Change Nr,Title 20004612,CHANGE BOX QTY TO BE 20 PCS
Date of issue 26.11.2018

Change the quantity per box

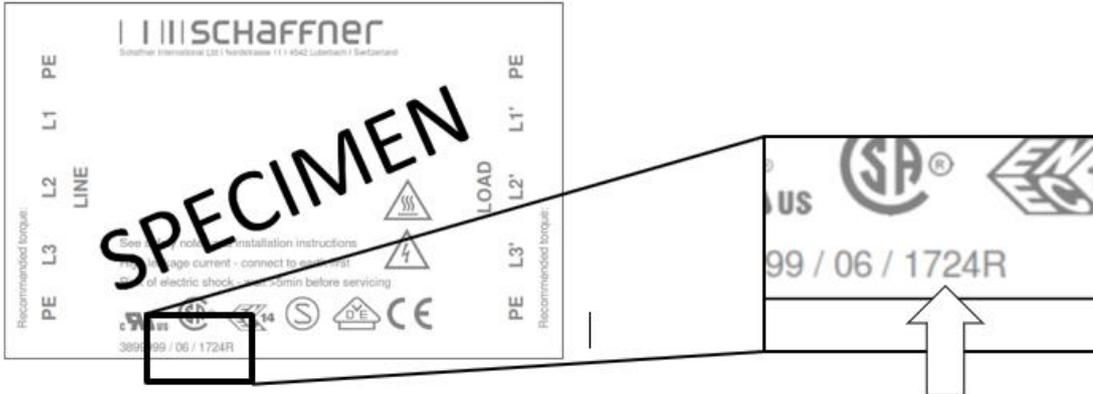
Size of box and quantity per box will change to a smaller box.
